Subject: **Indian Point 3 Nuclear Power Plant**
Docket No. 50-286
Response to Request for Additional Information Concerning
Implementation of the Station Blackout Rule (TAC No. 68557)

**Response to Request for Additional Information
Concerning Implementation of the Station Blackout Rule**

FIGURE 1.

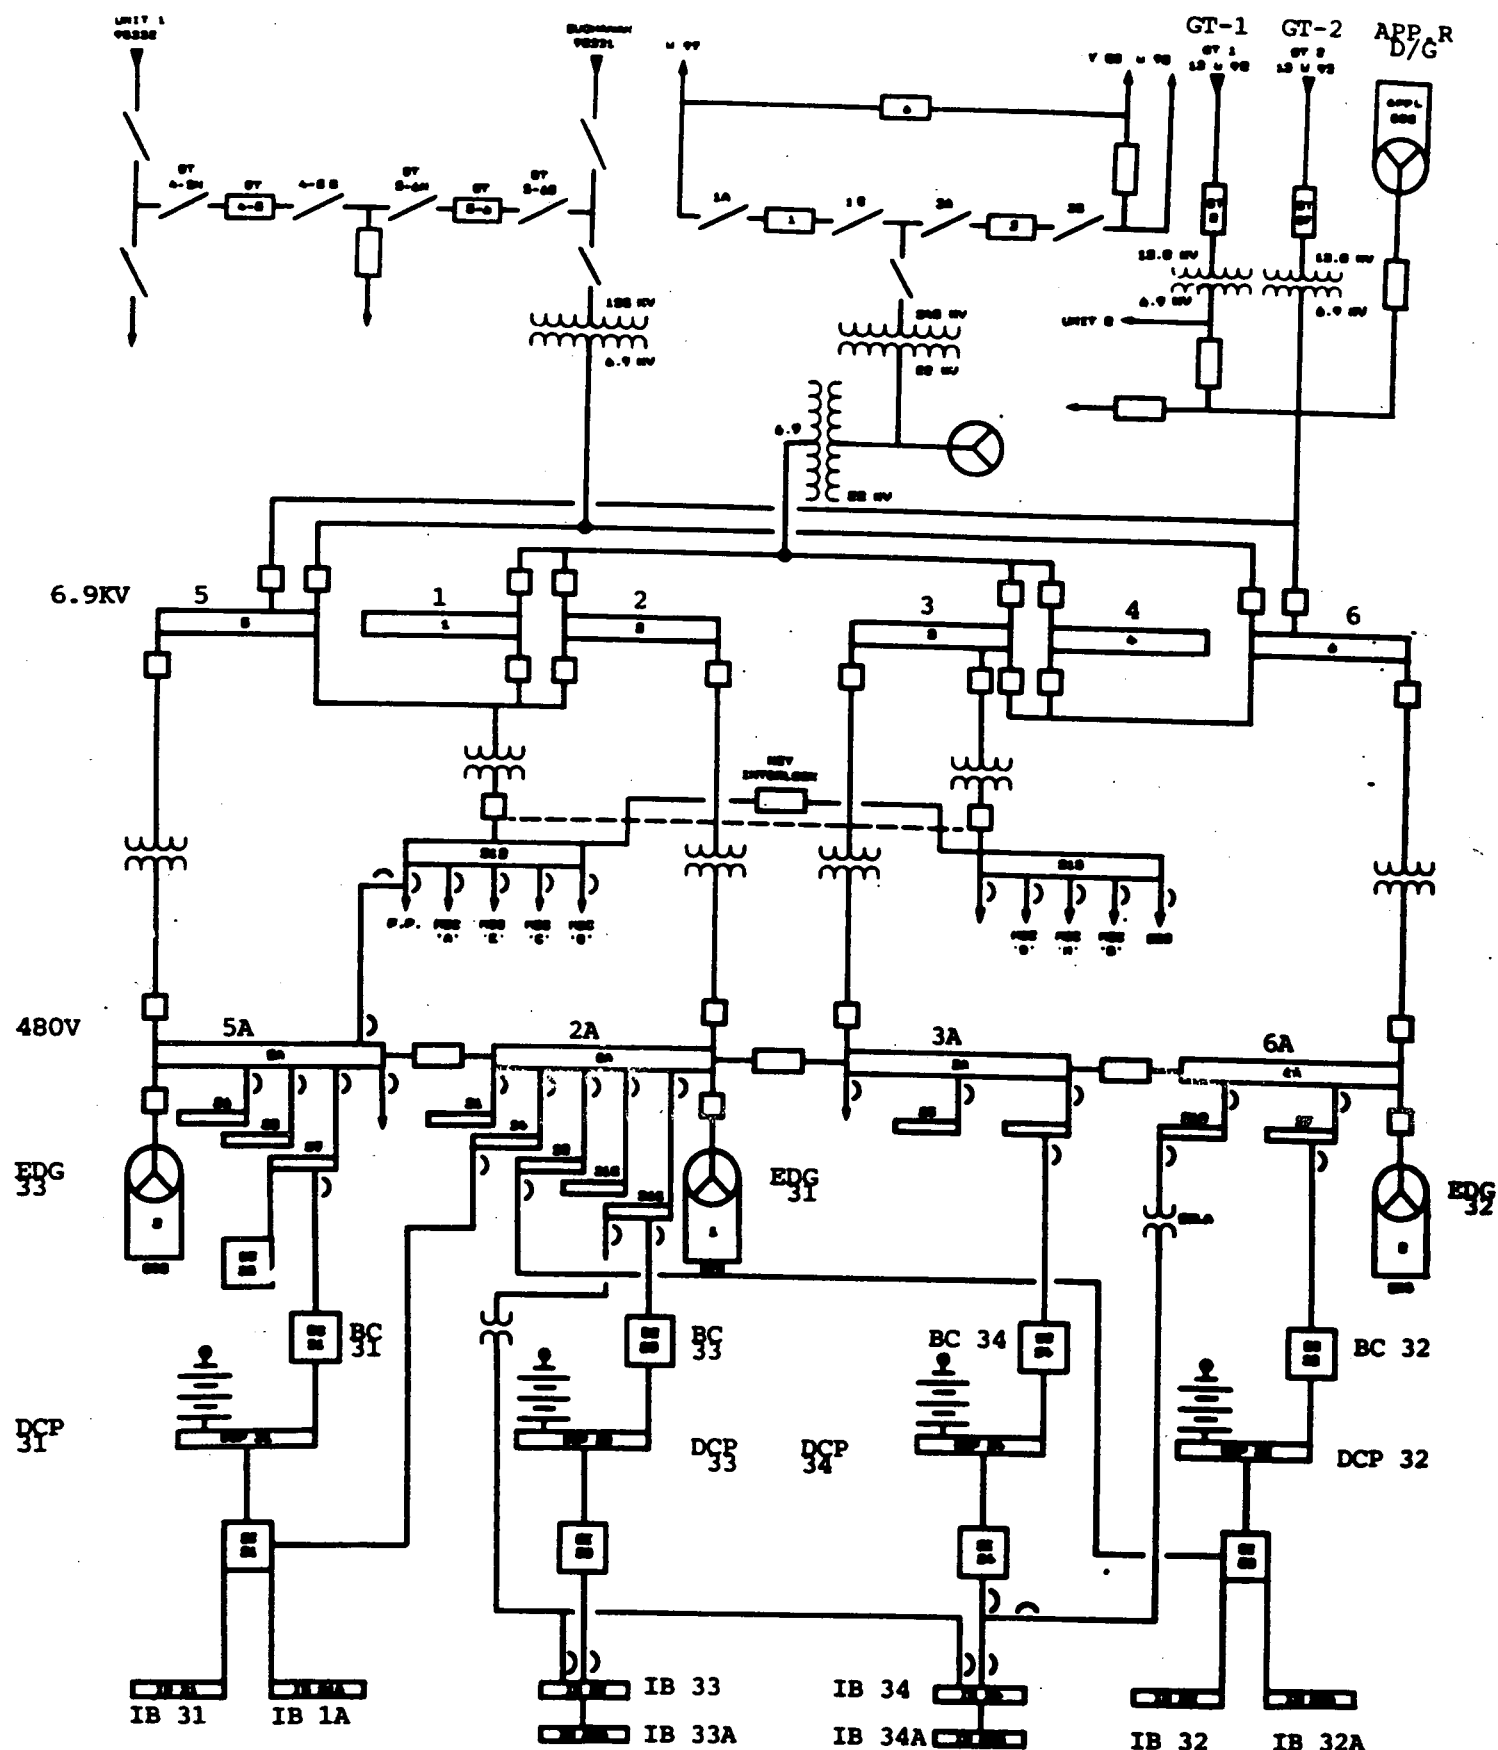
A. **Demonstrate that the use of the Appendix R diesel as an alternate AC power source complies with the guidance of Appendix B of NUMARC 87-00. In particular, address items B.3, B.8 and B.13.**

7. The 6.9kv tie-in from the Appendix R diesel to the gas turbine bus is through the normally open Appendix R diesel generator output breaker. (See Figure 1 for a simplified IP3 electrical distribution schematic.) The Appendix R diesel has no auto-start capability, and must be manually started and loaded onto the gas turbine bus.
